Plan Commission

Agenda

Monday, August 26, 2019

7. Staff recommendation and possible action regarding a Site Plan request for a warehouse addition at 1200 and 1212 Enterprise Drive (Parcels ED-2070 and ED-F0005-2). Submitted by Robert Mach, PE, Mach IV Engineering & Surveying LLC, authorized representative for Amerilux Holdings LLC & Novaks Cheese Enterprises, property owners.

SHEET 1 OF 4

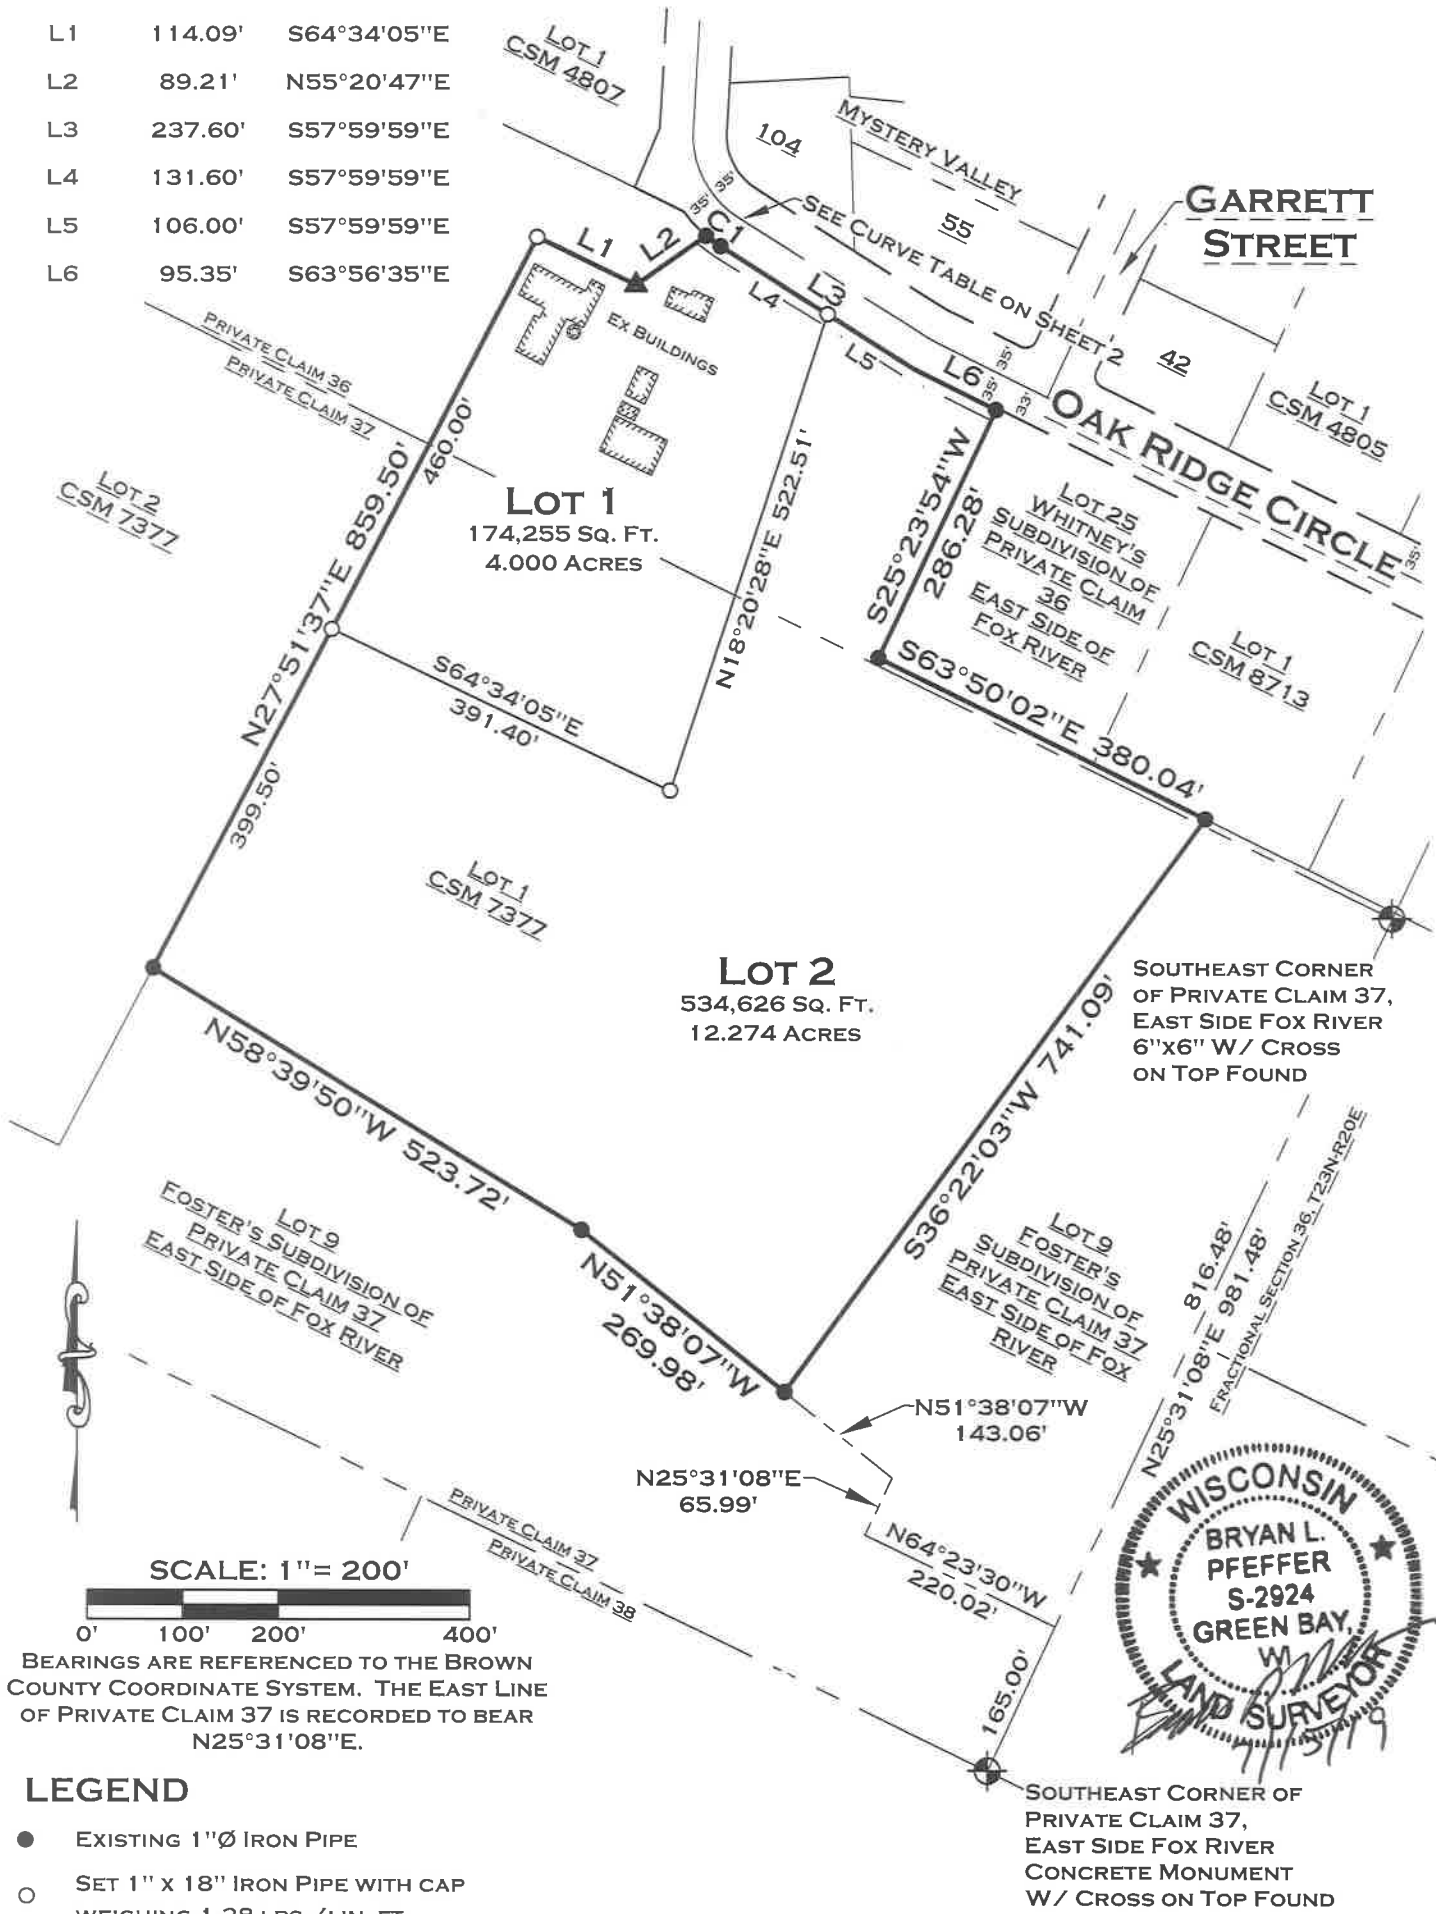
- The proposed east side boundary for Lot 1 will be rotated slightly in order to be perpendicular to Oak Ridge Circle. This change request was made by the Town of Ledgeview and is also referenced in City Code 46-4(g)(3)(6) for 'lot lines.'

- There are two issues that must be addressed for the CSM:
 - The City of De Pere Certificate should be modified to reference the date the Clerk signs the document AND the date the City of De Pere approved the document.

- Also the signature line name should be revised to read Carey E. Danen, City Clerk.

1. Meeting all other state and local regulations, including Brown County Planning Commission and Town of Ledgeview.
2. The City of De Pere Certificate should be modified to reference the date the Clerk signs the document and the date the City of De Pere approves the document. Also the signature line name should be updated to read Carey E. Danen, City Clerk.

Sheet One of Four

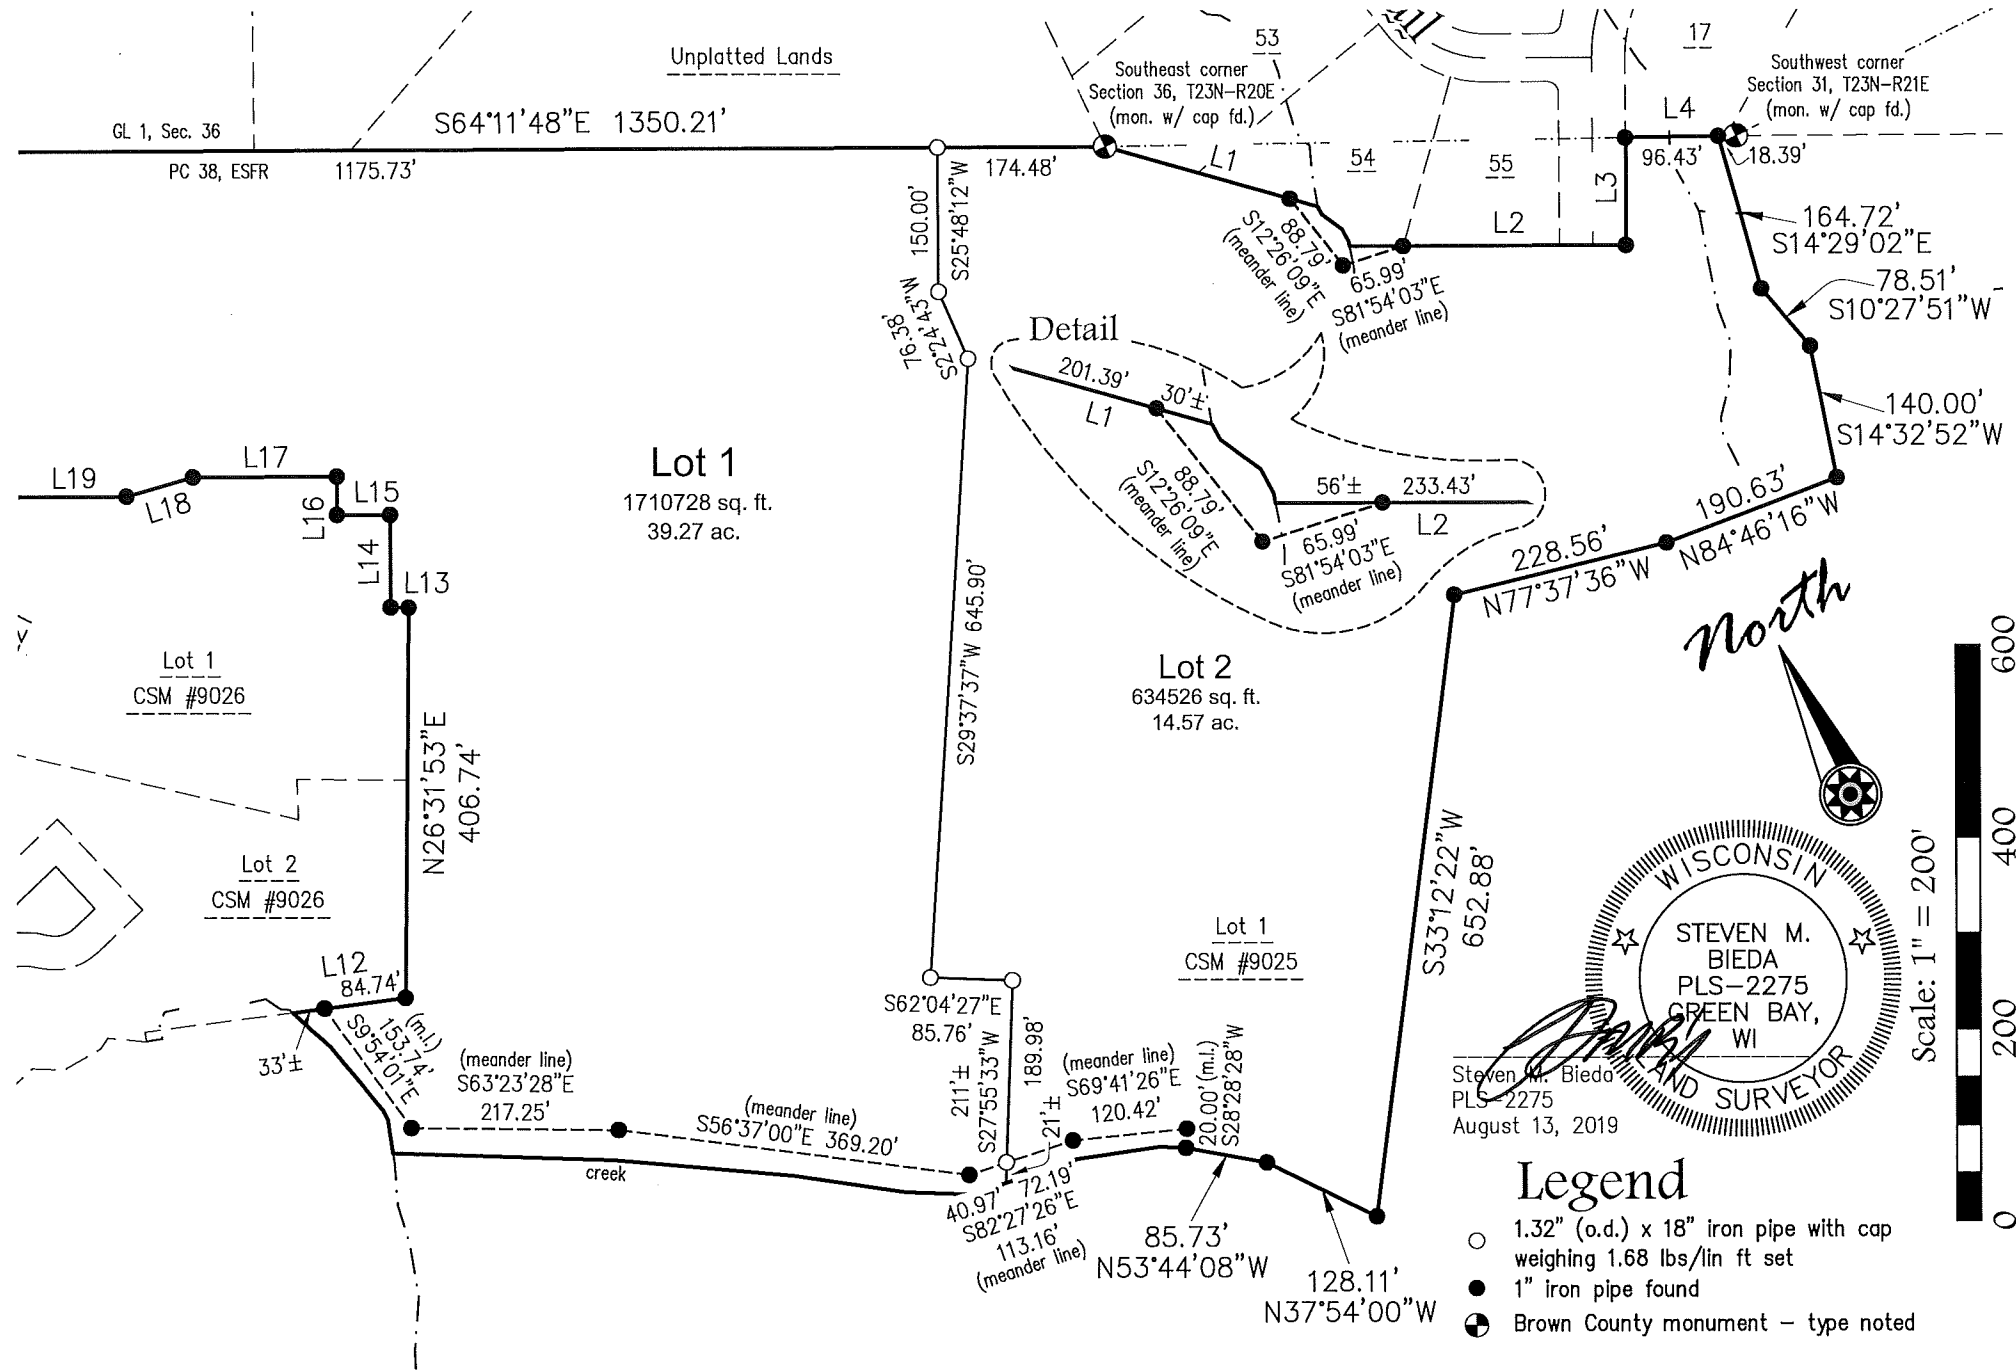
- There are three issues that must be addressed for the CSM:
 - The City of De Pere Certificate should be modified to reference the date the Clerk signs the document AND the date the City of De Pere approved the document.

- The signature line name should be revised to read Carey E. Danen, City Clerk.
 - The street Royal Vista Trail is expected to extend through Lot 2 and eventually provide a connection to Heritage Road. The dedicated right-of-way, or a future street, through Lot 2 should be shown.

1. Meeting all other state and local regulations, including Brown County Planning Commission and Town of Ledgeview.
2. The City of De Pere Certificate should be modified to reference the date the Clerk signs the document and the date the City of De Pere approves the document. Also the signature line name should be updated to read Carey E. Danen, City Clerk.
3. The extension of Royal Vista Trail should be shown on the CSM as either a future street or a dedication right-of-way.
 - a. The surveyor confirmed that that the street will get dedicated through Lot 2 in a plat that will follow.

PROJECT MANAGER:	C. VANDEWETTERING
DESIGNER	R. MACH
DRAWN BY:	RPH
EXPEDITOR:	B. FARRELL
SUPERVISOR:	T. WENZLAFF
CONTRACT NO:	62234
IED NO:	---
DATE:	JULY 31, 2019
SHEET:	C2.1

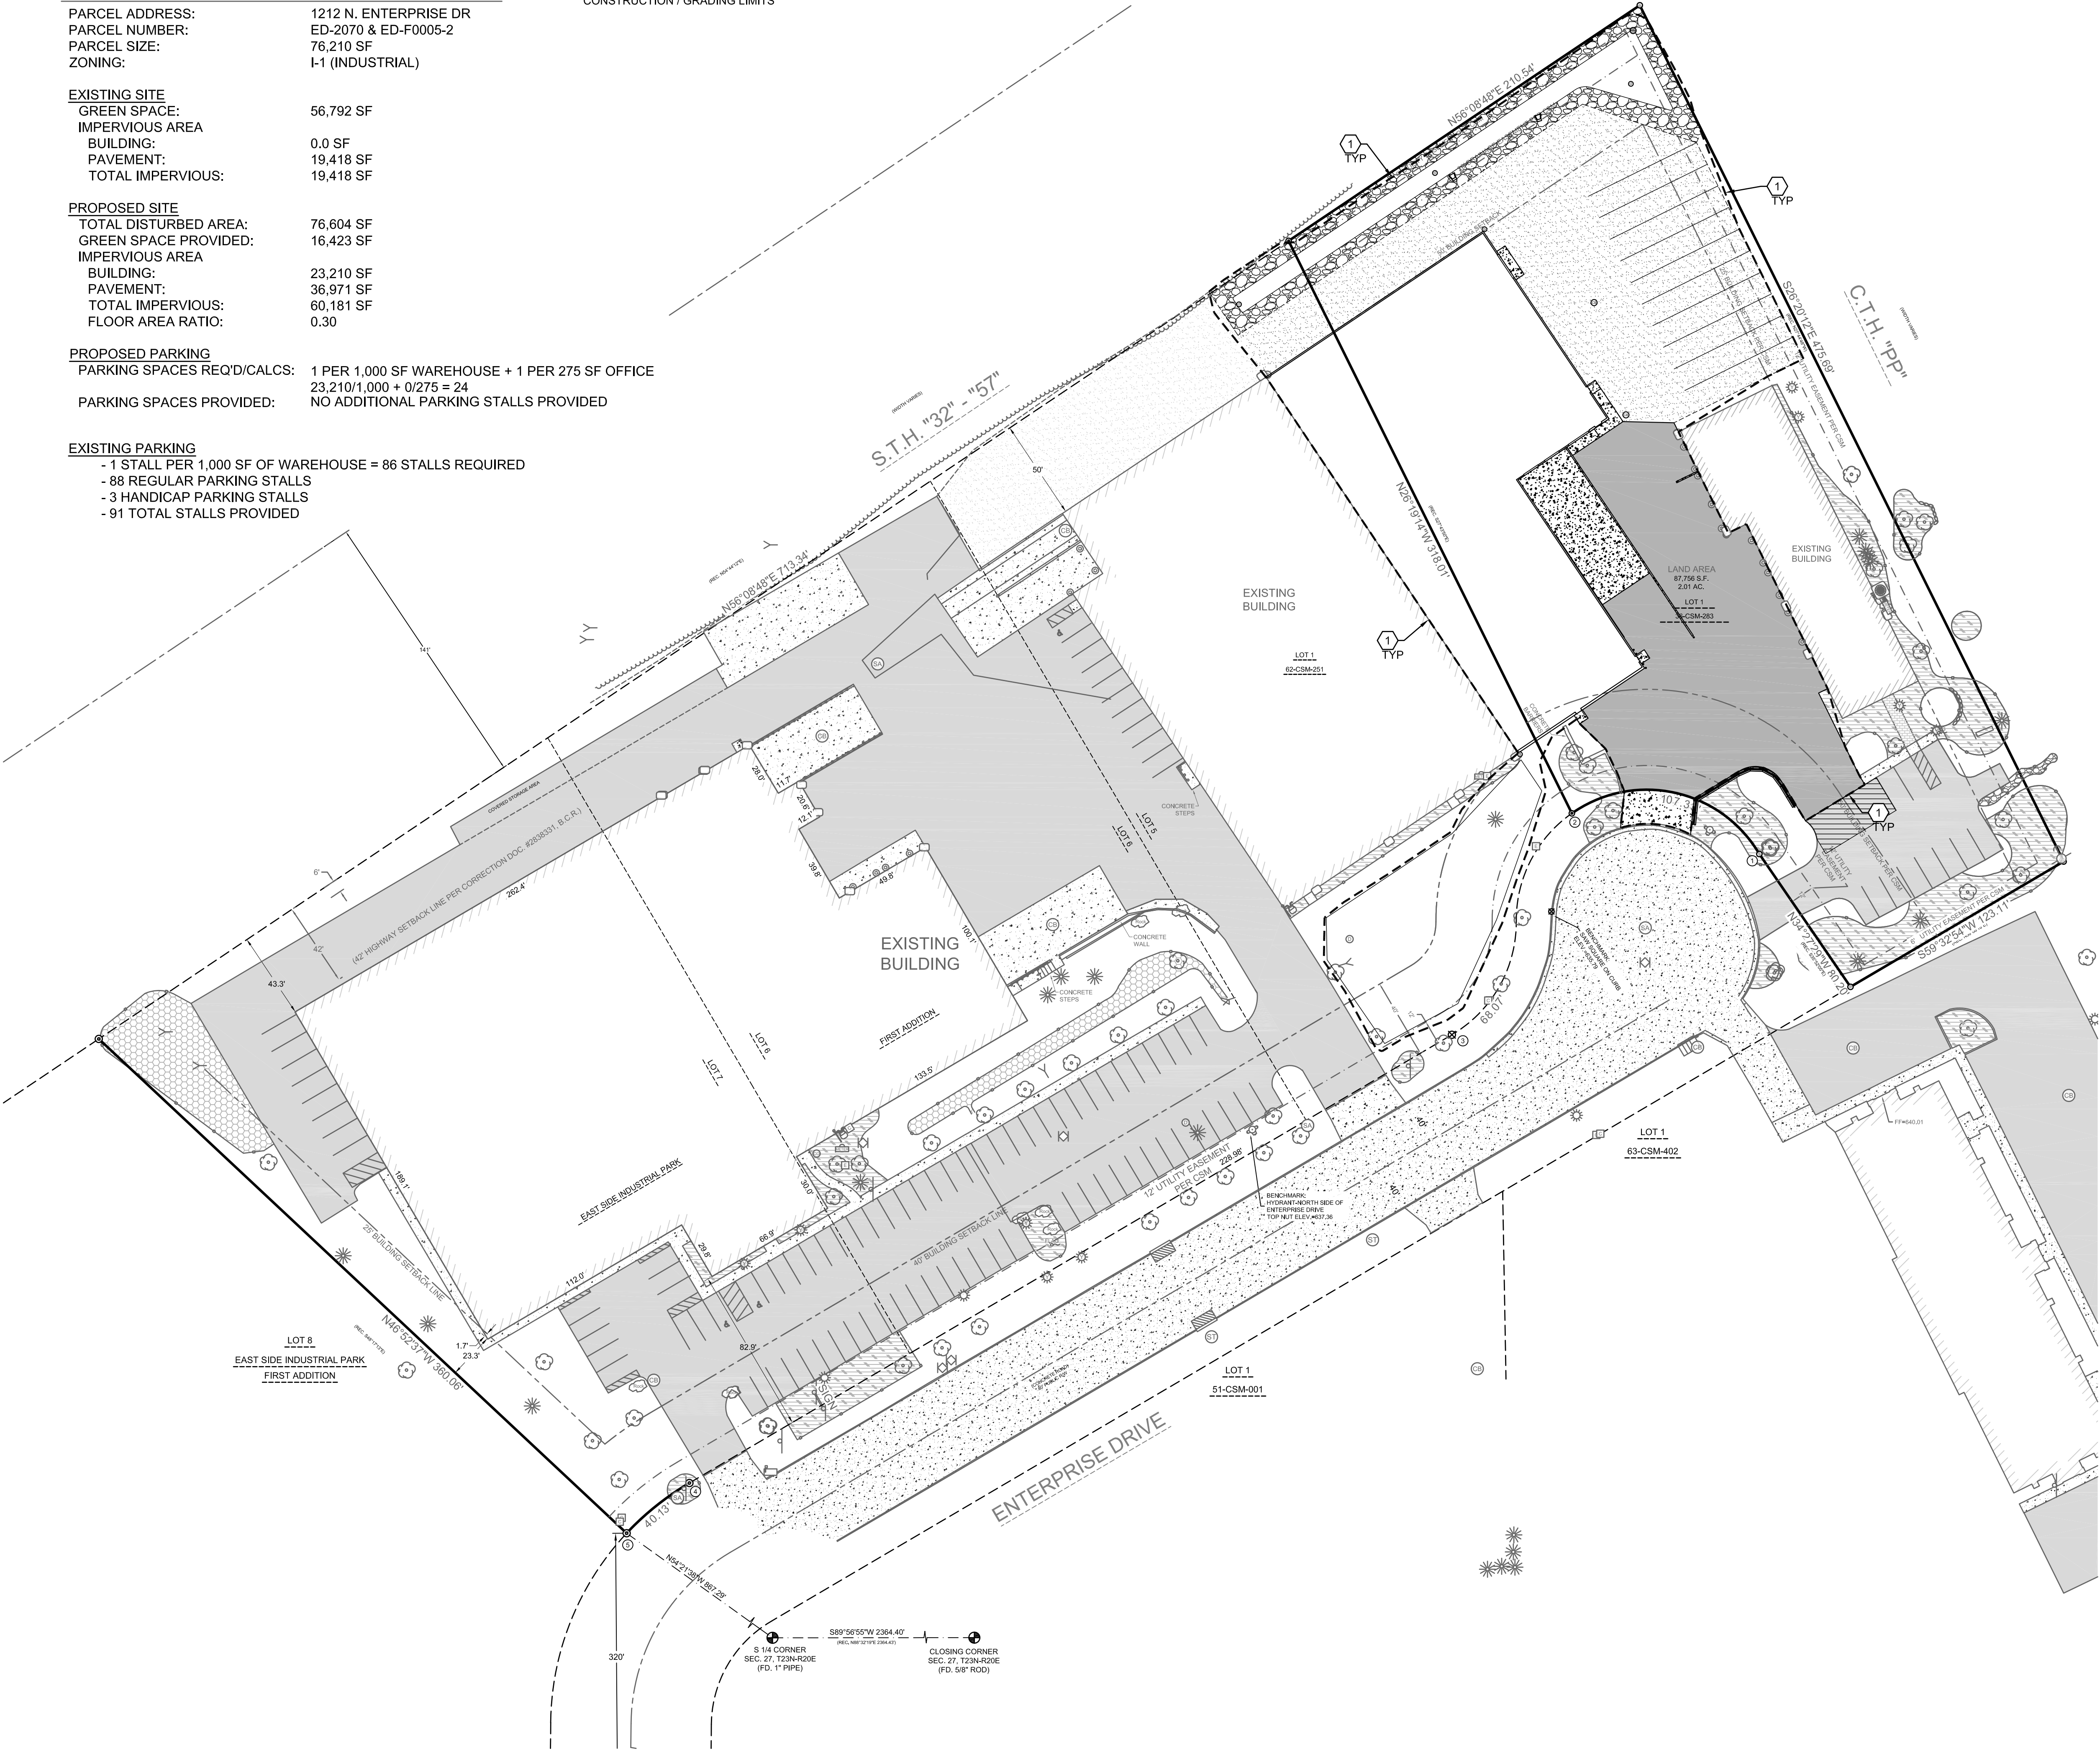
4. Sheet C2.1 - Driveway approach needs to have a sidewalk section shown. Sidewalk section should be approximately 6" off the right-of-way line. This is pursuant to detail F on sheet C6.0.

5. Sheet C2.1 - The large modular block retaining wall is not permitted in the City right-of-way or the easement area without a revocable occupancy permit. It is considered a structure and would need to be removed or replaced at the owners expense should a public utility need to be repaired in the area. It is best not to have it at all.

6. Sheet C2.1 - Sheet Key Note #8 should be labeled as 4" striping.
7. Sheet C3.0 - Turn off the existing contour layer from this sheet. It is too confusing to read where the existing landscaping was once located. The contours are not smooth and are creating issues.
